March 12, 2018

Bureau of Land Management  
Attn: Mike Robinson  
Casper Field Office  
2987 Prospector Drive  
Casper, Wyoming 82604  
WY\_CasperMail@blm.gov

Anadarko Petroleum Corporation, Chesapeake Energy Corporation, Devon Energy Corporation, EOG Resources, Inc., and SM Energy (collectively, “the Operator Group”) appreciate the opportunity to submit comments on the Draft Environmental Impact Statement (DEIS) for the Converse County Oil and Gas Project (“Project”), 83 Fed. Reg. 3,767 (Jan. 26, 2018). These comments supplement any individual comments submitted separately by members of the Operator Group (individually “Operator”). The Operators are the Project applicants. The Operators’ ability to exercise their valid existing rights within the acreage encompassing the Project (the “Project Area”) depends on BLM’s issuance of a Final Environmental Impact Statement (FEIS) and Record of Decision (ROD).

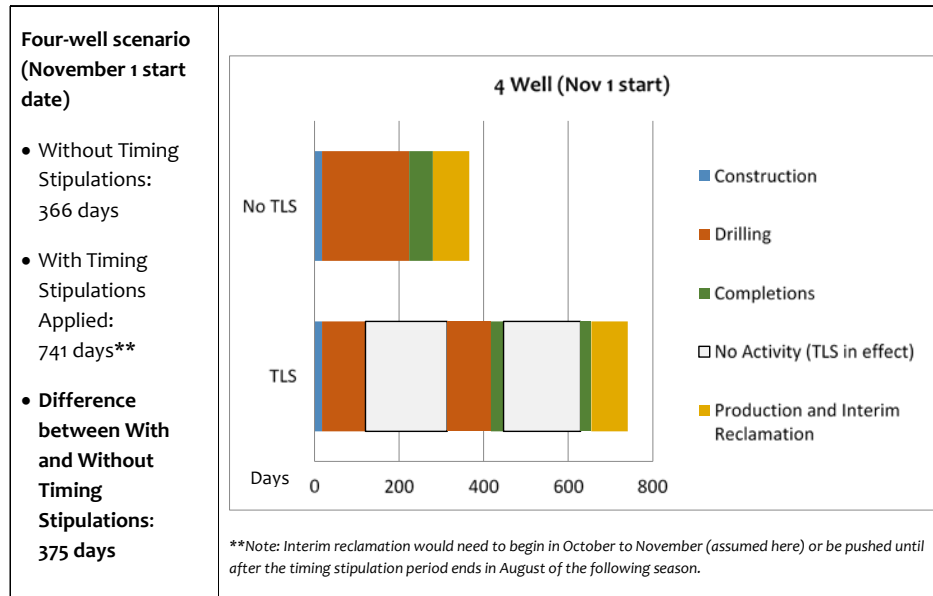
First, application of timing stipulations will increase the amount of time necessary to develop all wells on a given surface location. Application of timing stipulations requires an Operator to stop development and move a drilling rig off a location. By allowing year-round development, an Operator does not need to move the drilling rig off the location. Thus, an Operator can finish operations on a four-well location between six months to a year more quickly than if the Operator adhered to timing stipulations<sup>3</sup>:

The analysis of Alternative C does not acknowledge the significant environmental benefits of fewer rig moves and substantially reduced development times. Rather, the DEIS incorrectly assumes that application of timing stipulations under Alternative C will categorically reduce environmental impacts. The DEIS must be revised to disclose the potential impacts resulting from application of timing stipulations under Alternative C.

**Comparison of heavy and light truck round trips for mobilization/  
demobilization for an eight-well pad with and without TLS**

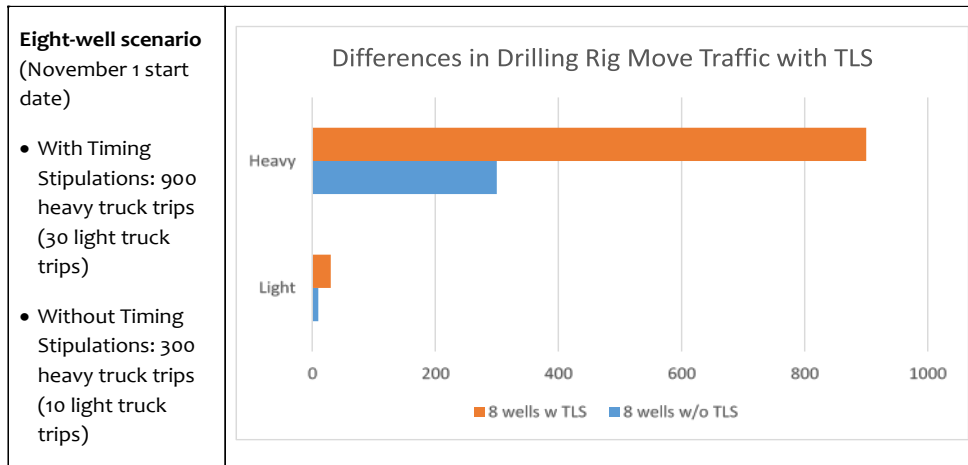
If eight wells are drilled from a single location,<sup>4</sup> development times associated with year-round development are reduced even more; depending on the time of year when development commences, year-round development can reduce the length of development by more than 18 months (567 days).

Most notable, the DEIS assumes that the same number of wells will be drilled during the 10-year Project timeframe, even though the development time for a given location will be extended by as long as a year on four-well pads and nearly two years for eight-well pads, even though Alternative C would increase the number of eight-well pads in the Project. *See* DEIS, pg. 2-35, lines 7–10 (stating Alternative C “would provide for drilling the same number of wells (5,000) at the same drilling rate (500 wells per year) as Alternative B”). Because application of timing stipulations significantly increases the length of time necessary to develop a single pad, and because timing stipulations limit access to much of the Project Area for six months of the year, BLM cannot assume that the same number of wells can be drilled at the same rate over a 10-year period under Alternative C as will be drilled under Alternative B. Although the analysis of socioeconomic impacts notes the increased drilling time, *see id.* pg. 4.11-45, lines 21–22, the analysis of other resources fails to account for increased drilling time.

**Comparison of heavy and light truck round trips for mobilization/ demobilization for an eight-well pad with and without TLS**

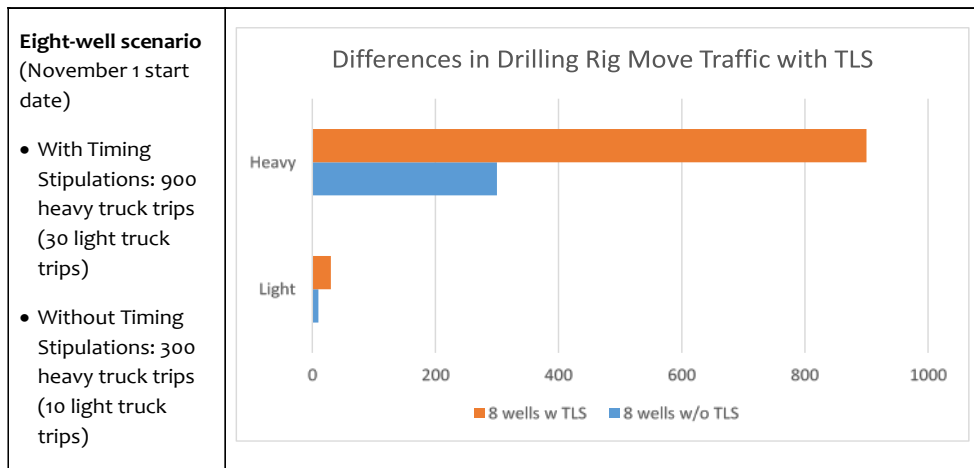
Application of timing stipulations also requires Operators to move drilling rigs on and off locations during the season when activities are limited. Moving drilling rigs throughout the Project Area carries its own set of impacts. Most significant, moving drilling rigs increases truck traffic. The Operator Group estimates that application of timing limitations to development of an eight-well pad will increase truck traffic three-fold:

The DEIS, however, projects the exact same number of rig moves and truck trips under Alternative C as under Alternative B. *Compare* DEIS, pg. 4.13-3, tbl. 4.13-1 *with id.* pg. 4.13-9, tbl. 4.13-6 (assuming 10 light truck and 300 heavy truck trips per well). Elsewhere, the DEIS predicts that “[t]he overall number of rig mobilization and demobilization activities would be lower under Alternative C than under Alternative B.” *Id.* pg. 4.11-45, lines 16–17. The DEIS must be revised to account for the increased truck traffic resulting from application of timing stipulations. Furthermore, because truck traffic trips will increase, Alternative C presents a risk of increased vehicle emissions and fugitive dust resulting in higher emissions of PM<sub>10</sub> and PM<sub>2.5</sub>, but the DEIS does not disclose such potential impacts. *See id.* pg. 4.1-35, lines 30–42. Increased truck traffic also can increase noise levels, yet the DEIS describes noise impacts under Alternative C as “similar in type but less in intensity than under Alternative B.” *Id.* pg. 4.7-5, lines 15–16. Increased truck traffic could also increase the risks of traffic accidents and accidental releases, yet the DEIS also does not discuss these risks. *See id.* pgs. 4.4-8 – 4.4-9. Finally, the DEIS does not account for potential disruptions to wildlife resulting from increased traffic. *See id.* pgs. 4.18-18, lines 30–35; pg. 4.18-35, lines 29–38.

The increased duration of development and the increased rig moves result in impacts that must be acknowledged and analyzed in the DEIS. Accordingly, BLM must, at a minimum, revise the following discussions of Alternative C in the DEIS to account for these increased impacts: rate of development (section 2.5.1); air quality (section 4.1.3); noise (section 4.7-5); soils (section 4.12.3); vegetation (section 4.14.3); truck traffic (section 4.13.3); and wildlife (section 4.18.3).
